ATLANTA JUNCTION
CORB COUNTY PERMIT PLOT PLAN

PETITION NO: SLUP-22

APPLICANT: Magellan Pipeline Company, LP

ZONING COMMENTS: Staff Member Responsible: Terry Martin, MPA

PLOT PLAN

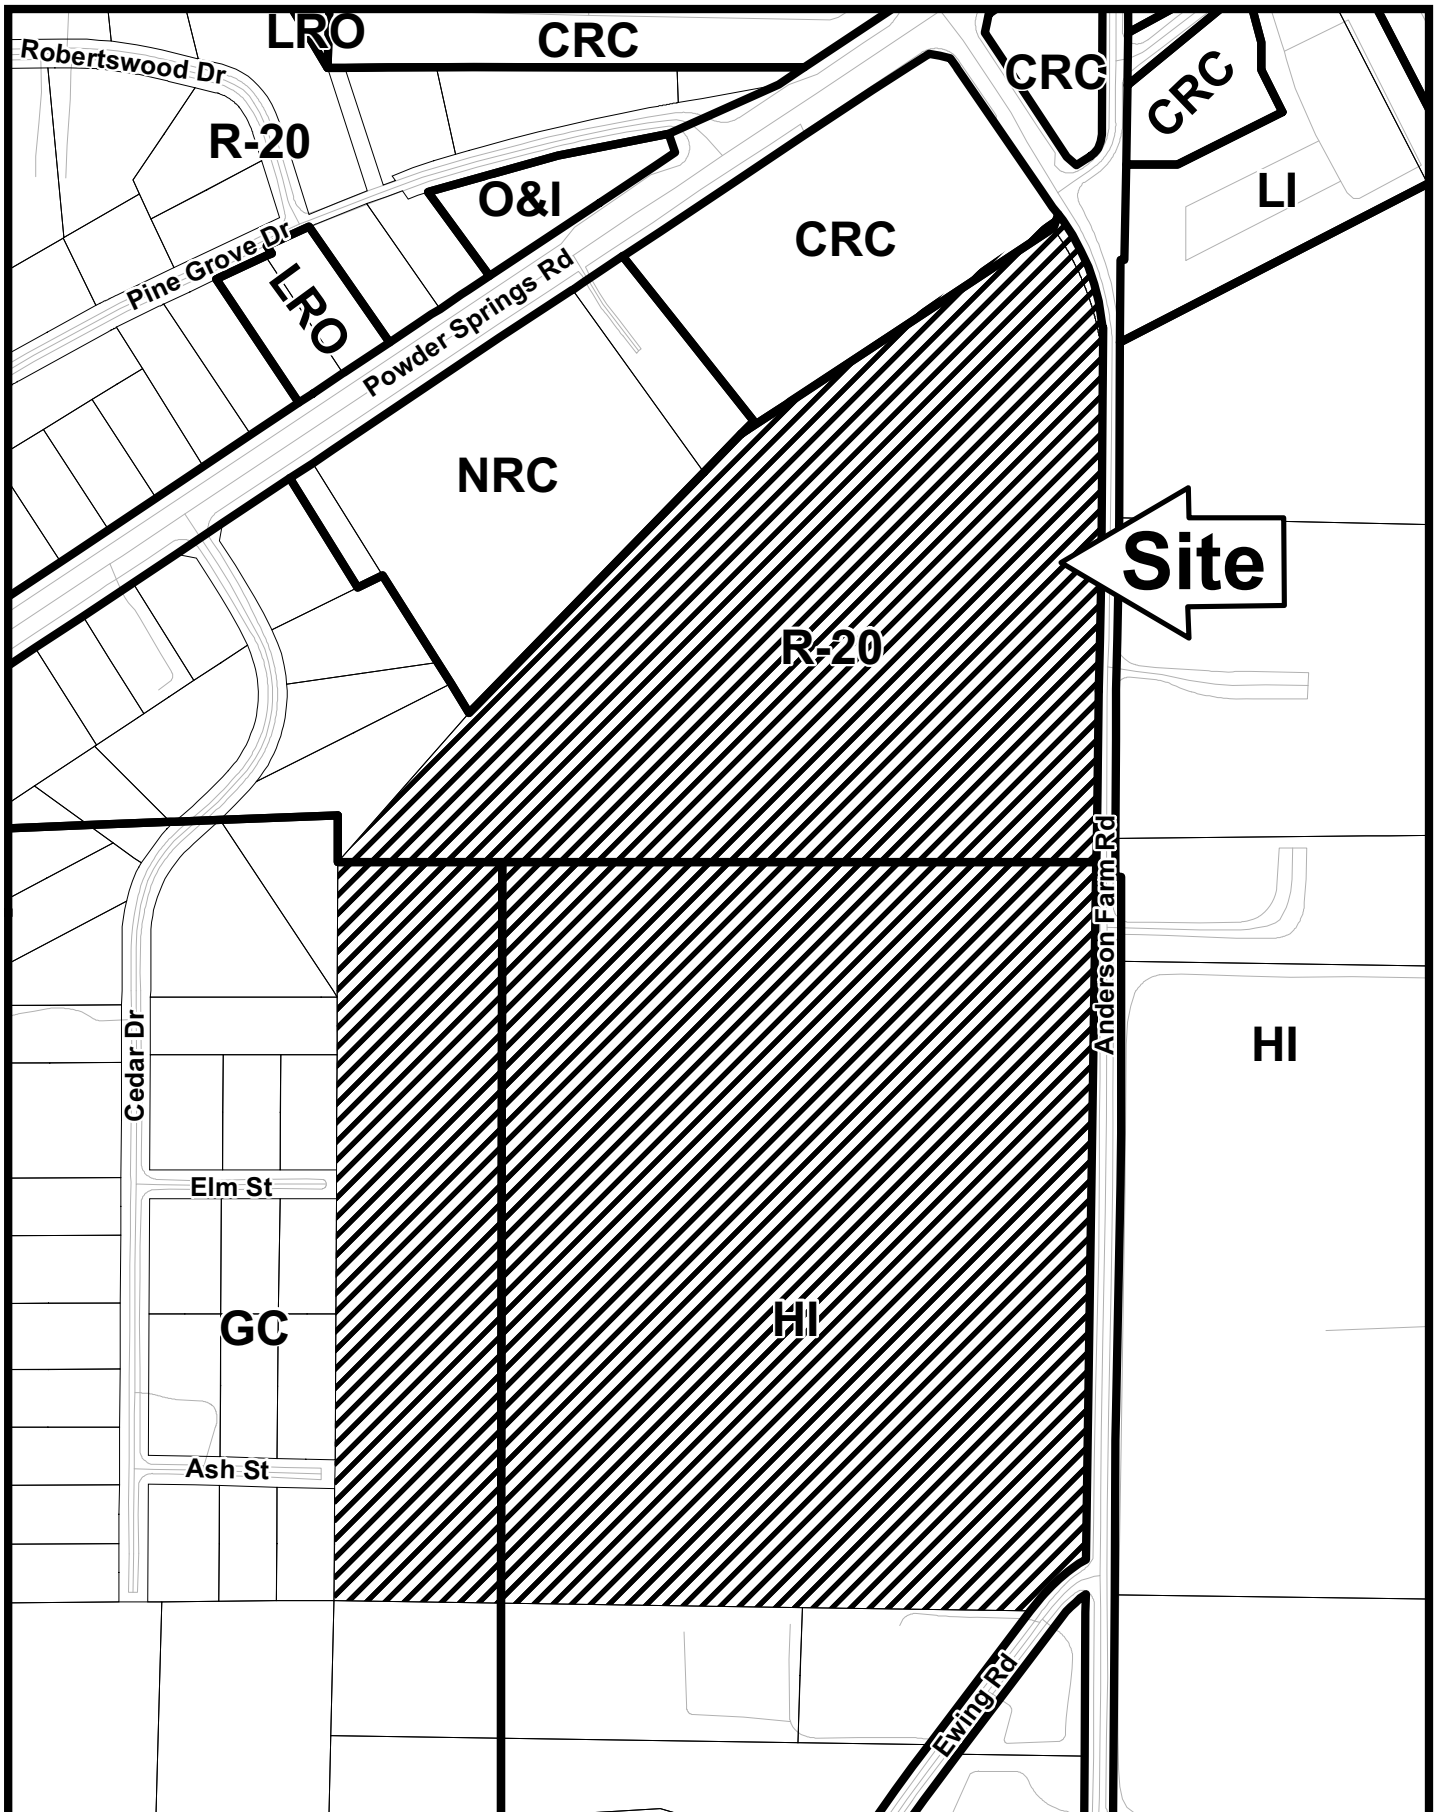
Recommend applicant consider entering into a development agreement pursuant to O.C.G.A. 36-71-13 for dedication of the following system improvements to mitigate traffic concerns: a) donation of right-of-way on the west side of Anderson Farm Road, a minimum of 40’ from the roadway centerline.

Recommend curb, gutter, and sidewalk along Anderson Farm Road frontage.

Recommend eliminating the proposed access closest to Ewing Road.

Recommend the proposed gate meet Cobb County Development Standards.

1. The entire site drains to the west through the adjacent Flint Hills Subdivision via two primary discharge points. The majority of the site will remain undisturbed with the proposed facility to be located near the southeast corner.
2. The proposed site plan may require a stream buffer variance, however it appears that the layout can be revised to eliminate the need for a variance. This issue can be addressed in Plan Review.
3. A Notice of Intent must be filed with the Georgia Environmental Protection Division for coverage under the NPDES General Permit to discharge stormwater associated with industrial activity. Any requirements associated with this permit must be addressed. A copy of the Stormwater Pollution Prevention Plan must be provided to the Stormwater Management Division.
